STAFF REPORT
(Preliminary Plat)

CASE NUMBER: SUB 2000-04 -- RIVERSIDE AIRPARK ESTATES ADDITION

VICINITY MAP

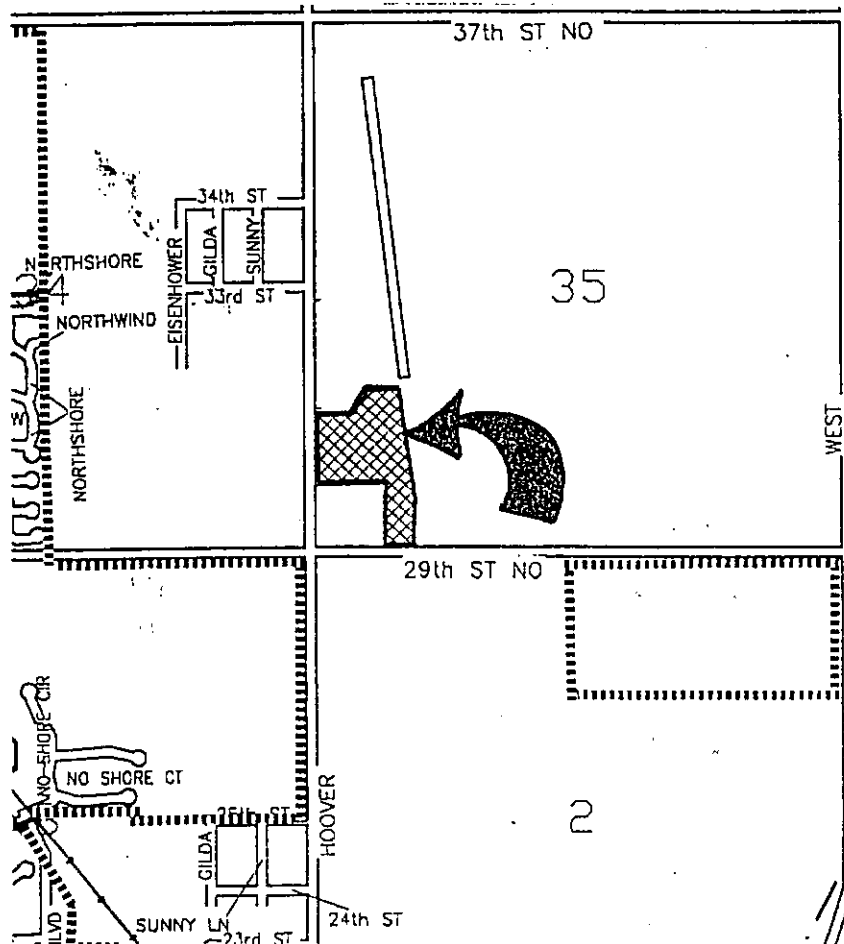
- F. County Engineering needs to comment on the need for access controls. The plat should denote complete access control along 29th St. North except for one opening to the private street. On the final plat, access controls shall be referenced in the plattor's text.

- G. The plat proposes a private drive, Reserve A, to access 22 lots, exceeding the 3-lot limitation imposed by the Subdivision regulations. A modification will need to be approved by the Subdivision Committee.

- H. The aircraft access easement located at the terminus of the Reserve A (Lots 8 and 9, Block B) should also be designated as an emergency access easement. The length of Reserve A (1,600 feet) exceeds the 600-ft maximum imposed by the Subdivision regulations and an emergency access easement is needed to provide two points of access for County Fire Department.

- I. Lots 1, 2, 6, and 7 exceed the maximum lot width to lot depth ratio of 2.5 to 1. A modification will need to be approved.
- J. The access easements need to be established by separate instrument.
